Attachment 3

Technical Specification 3/4.2.3 - RCS Flowrate and Nuclear Enthalpy Rise  
Hot Channel Factor

Proposed Change

FIGURE 3.2-3 RCS TOTAL FLOWRATE VERSUS  $R_1$  AND  $R_2$ —FOUR LOOPS IN OPERATION

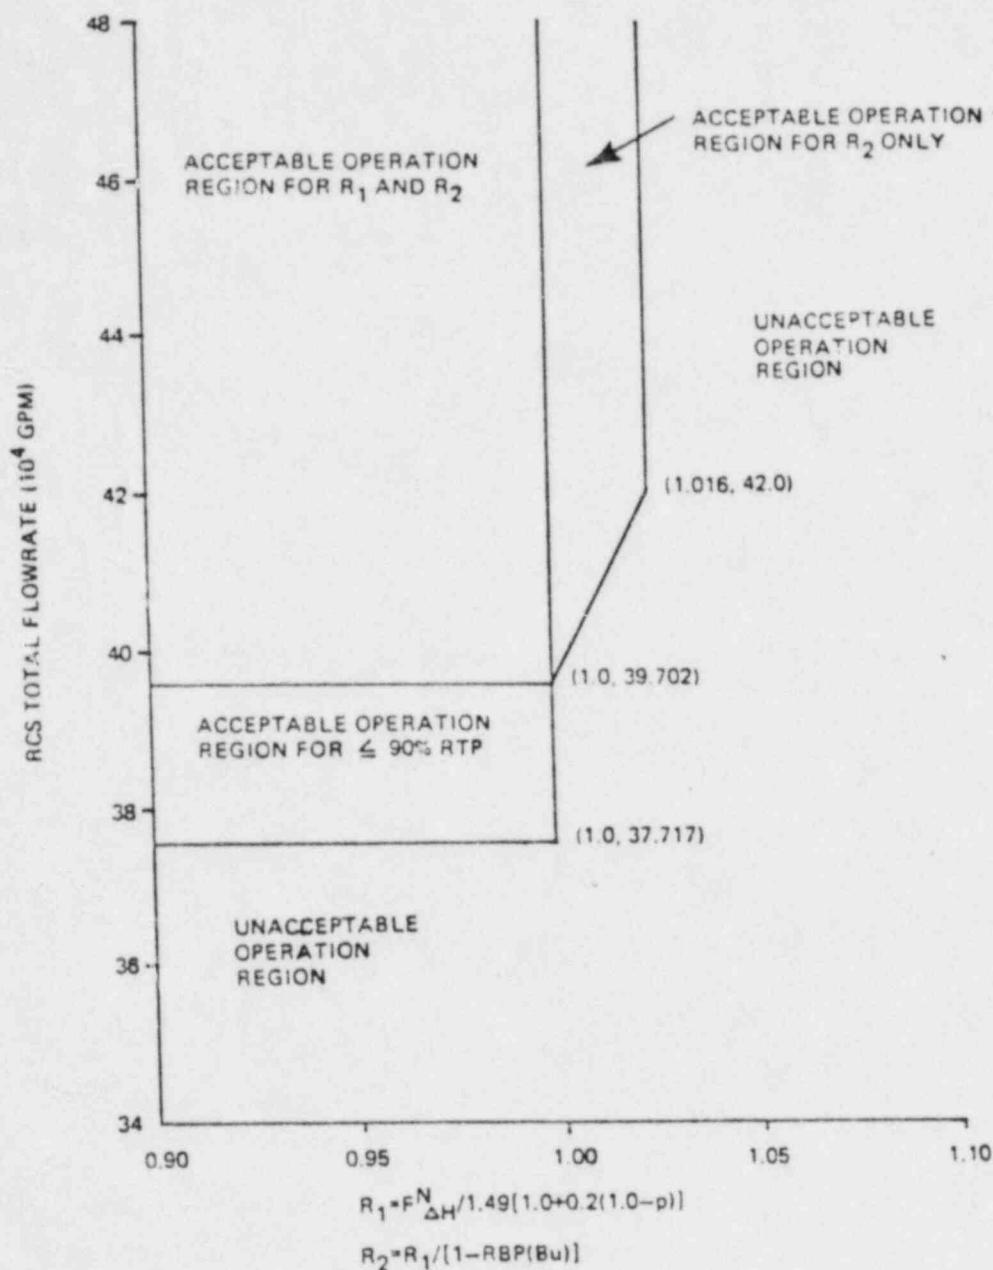
Revise Specification 3.2.3.e and Figure 3.2-3 to reduce the measurement uncertainty for total RCS flow. This results in a decrease in the minimum RCS flow for acceptable operation as shown on Figure 3.2-3. Revise Specifications 4.2.3.2 and 4.2.3.5 to indicate the measurement methods which provide the reduced uncertainty.

When RCS flow rate and  $F_{\Delta H}^N$  are measured, no additional allowances are necessary prior to comparison with the limits of Figures 3.2-3 and 3.2-4. Measurement errors of 1.7% for RCS total flow rate and 4% for  $F_{\Delta H}^N$  have been allowed for in determination of the design DNBR value.

d.  $F_{\Delta H}^N$  = Measured values of  $F_{\Delta H}^N$  obtained by using the movable incore detectors to obtain a power distribution map. The measured values of  $F_{\Delta H}^N$  shall be used to calculate  $R$  since Figure 3.2-3 includes penalties for undetected feedwater venturi fouling of 0.1% flow and for measurement uncertainties of 1.7% for flow and 4% for incore measurement of  $F_{\Delta H}^N$ , and

PENALTIES OF 0.1% FLOW FOR UNDETECTED FEEDWATER VENTURI FOULING AND FOR MEASUREMENT UNCERTAINTIES OF 1.7% FOR FLOW & 4.0% FOR INCORE MEASUREMENT OF  $F_{\Delta H}^N$  ARE INCLUDED IN THIS FIGURE.
